AGENDA
March 17, 2015
Town Hall BOS Meeting Room - 6:30 PM

TOWN OF MILFORD, NH
OFFICE OF COMMUNITY DEVELOPMENT
PLANNING DEPARTMENT
1 UNION SQUARE, MILFORD, NH 03055 TEL: (603)249-0620 WEB: WWW.MILFORD.NH.GOV

Subject: **Michael R Ciardelli, et. al./Heatherland Properties LLC – Ciardelli Fuel Company, Inc.** - Ciardelli Crossing & Nashua St – Map 32, Lots 27 & 28: Public Hearing for a major site plan to construct a 1,792 SF office addition with associated site improvements.

SITE & LANDSCAPE PLAN
MAP 32 LOTS 27 & 28
CIARDELLI FUEL COMPANY, INC.
467 NASHUA STREET
TOWN OF MILFORD
HILLSBOROUGH COUNTY, NEW HAMPSHIRE

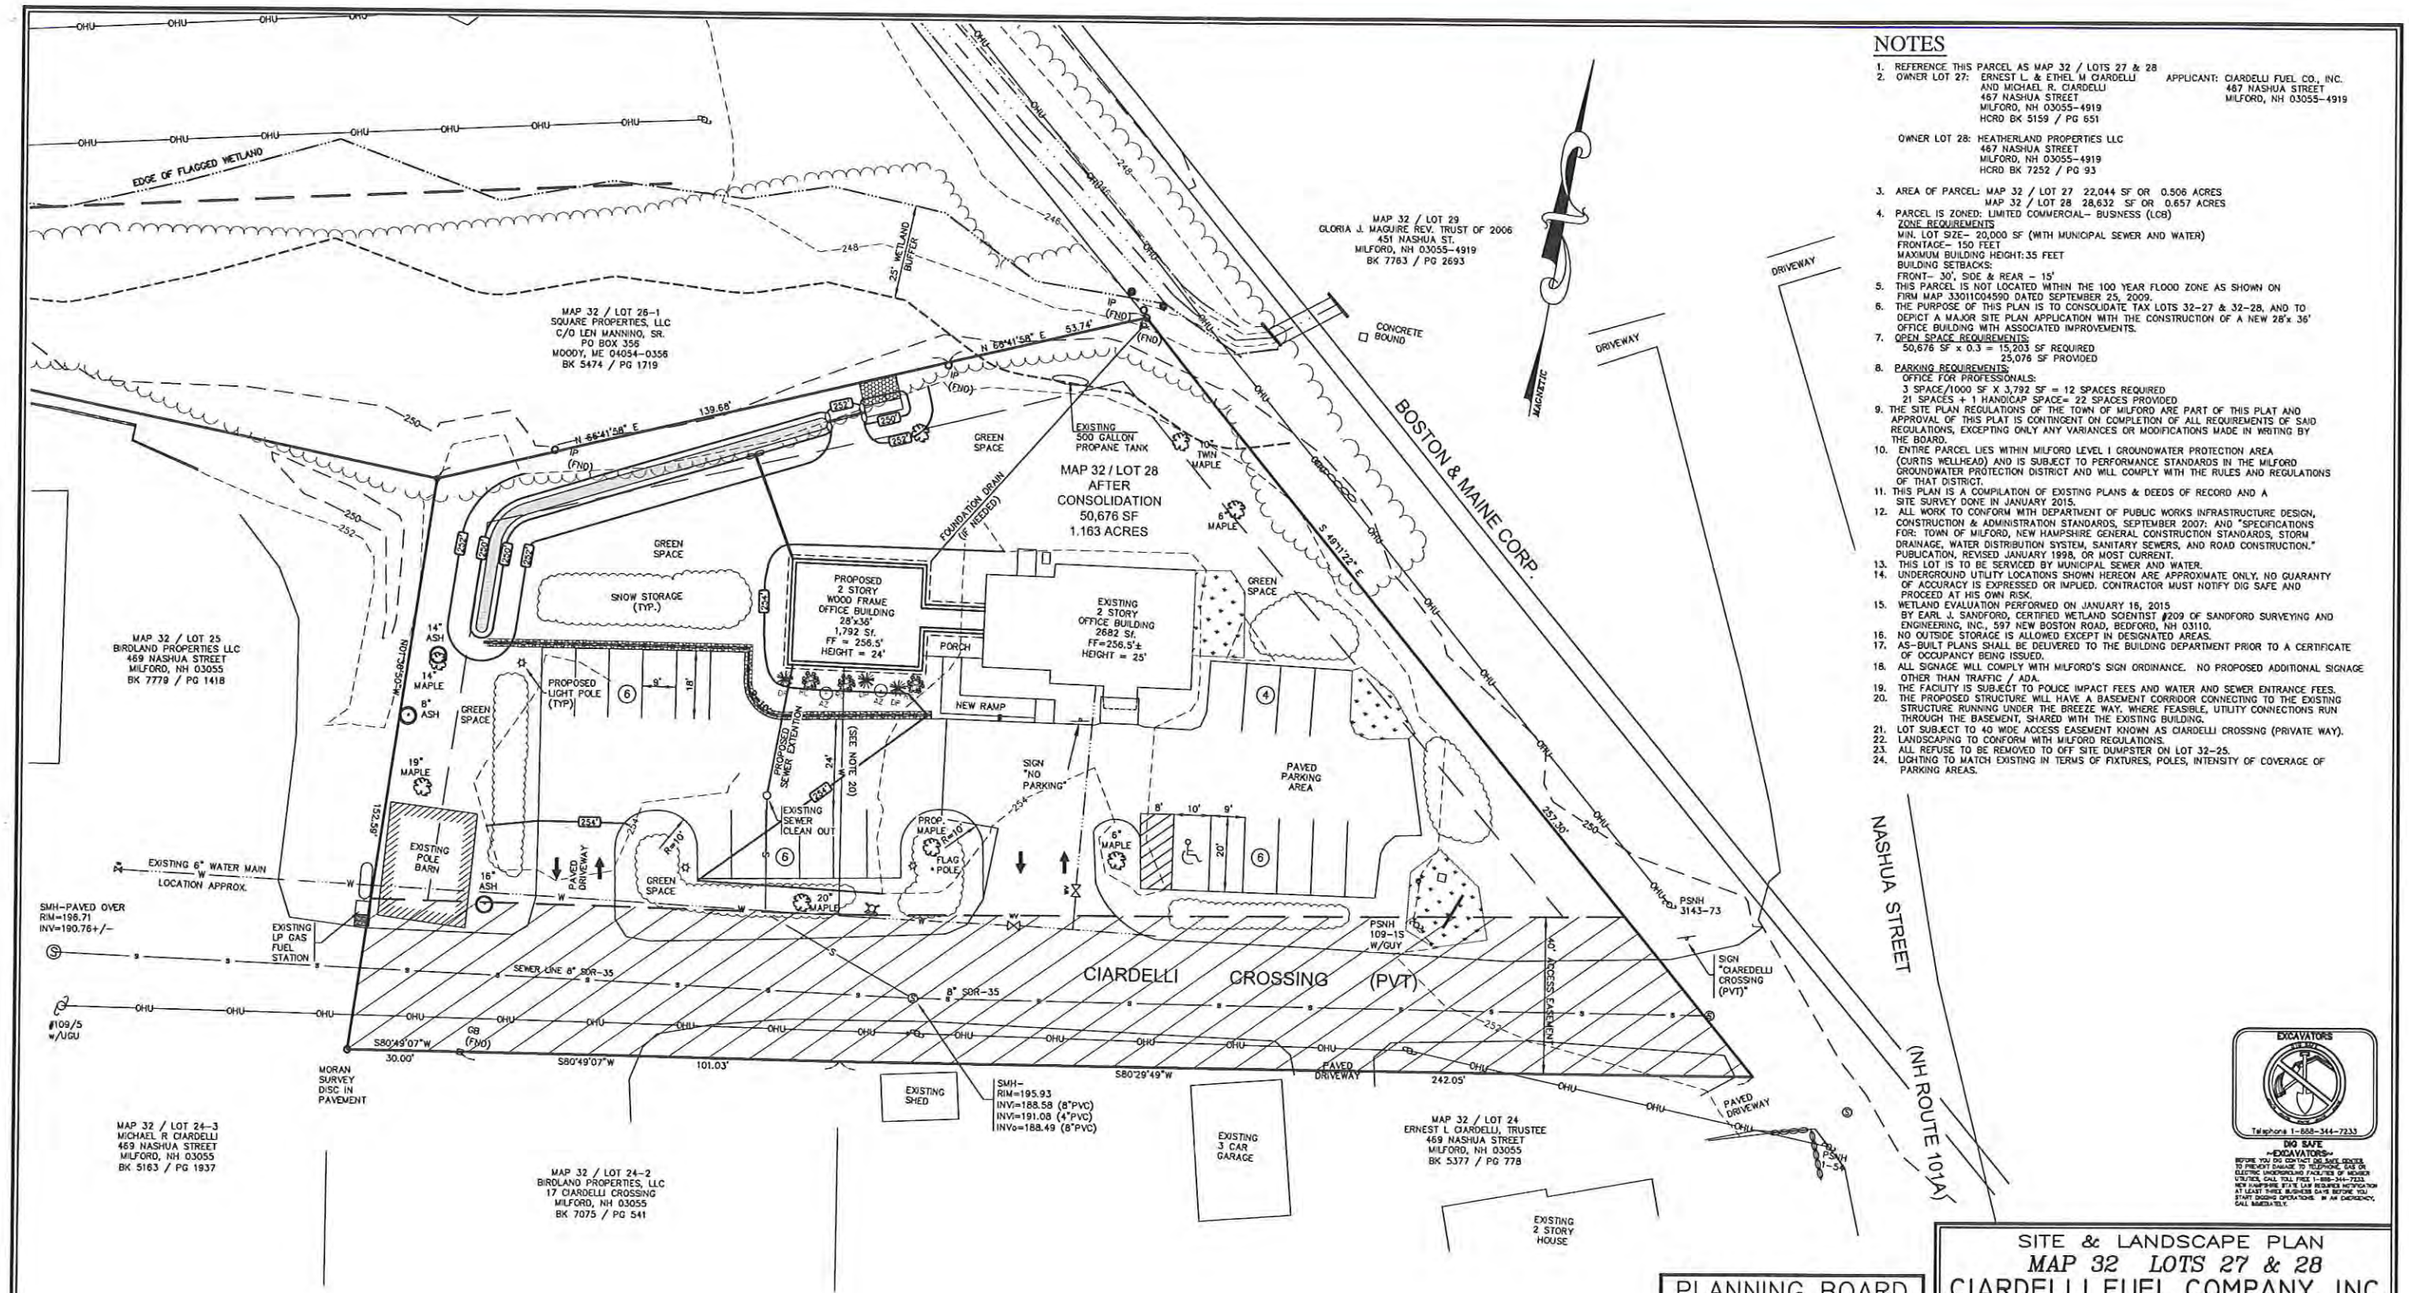
Building: An accessible route w/correct size ramp should be shown on the plans. Number of accessible parking spaces should be based on occupant load. The correct address numbers (see E911 comments) should also be posted before CO is issued.

Staff has no significant issues with the plan as presented. As stated in the Environmental Coordinators comments, the altered drainage now flows onto the abutting property (32-26-1). It is requested that the abutter provide a signed letter of agreement for the record. Also, as noted in the E911 comments, there are some issues regarding lot addressing. The plan states 467 Nashua Street; however according to town property cards, the existing Ciardelli Fuel building address is 5 Ciardelli Crossing. 467 Nashua Street is the abutting property to the south which houses Rodney C. Woodman Florist. The applicant will need to revise the plan to reflect the correct address of 5 Ciardelli Crossing or resolve the issue with E911 and assessing. Lastly, the Building Inspector has noted in their interdepartmental comments that the handicap accessible route being shown on the plan does not meet ADA requirements and will need to be extended.

8. Add language to note #24 stating that "All exterior lighting shall be downcast Per the Milford Development Regulations";
9. The applicant work with the Building Department to assure the handicap ramp is altered to meet ADA requirements;

10. Revise the plans to show correct address numbers.

STORM WATER MANAGEMENT PLAN
MAP 32 LOT 27 & 28
CIARDELLI FUEL COMPANY, INC.
467 NASHUA STREET
TOWN OF MILFORD
HILLSBOROUGH COUNTY, NEW HAMPSHIRE

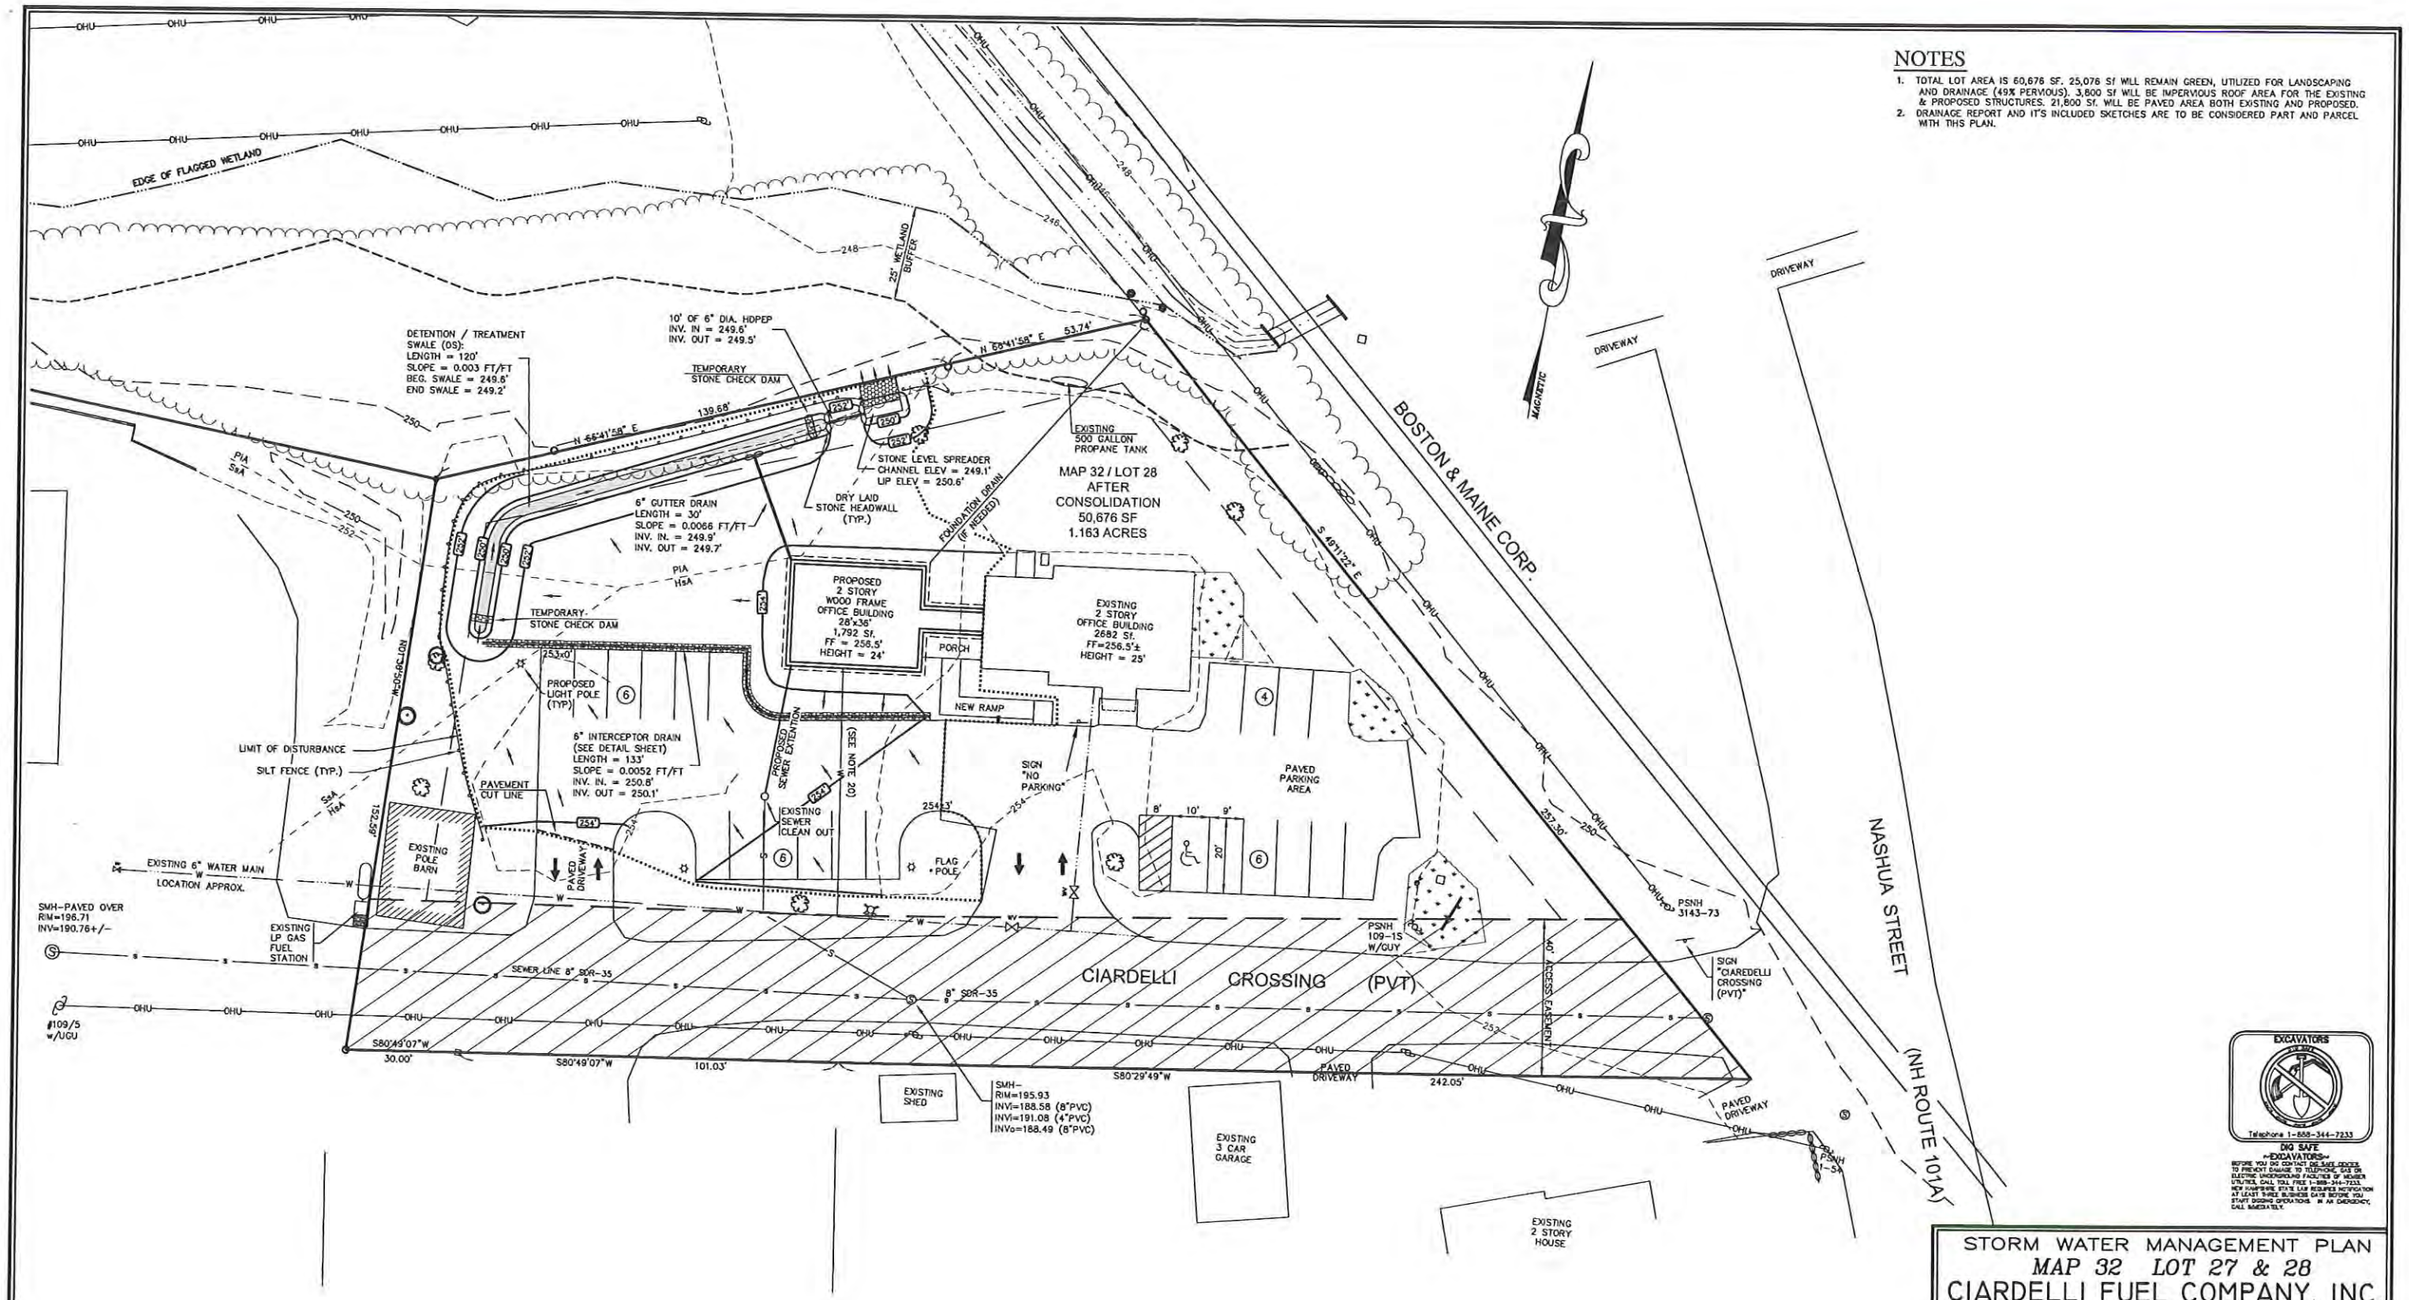
Environmental Coordinator: I've initially reviewed the stormwater plan and believe it will meet our requirements. My concern is regarding the alteration of drainage onto the abutting property. The project engineer has indicated that the owner has an agreement with the abutter and this can be provided in writing. I've requested that the abutter provide such a letter for the record.

6. Site plan and stormwater plan needs construction entrance/exit detail (project size allows for use of 50' residential detail);
7. A note be added to the plan stating the subject property lies within the Nashua and Elm Streets Overlay District and is subject to the requirements and restrictions set forth in Section 6.05.0 of the Milford Zoning Ordinance;
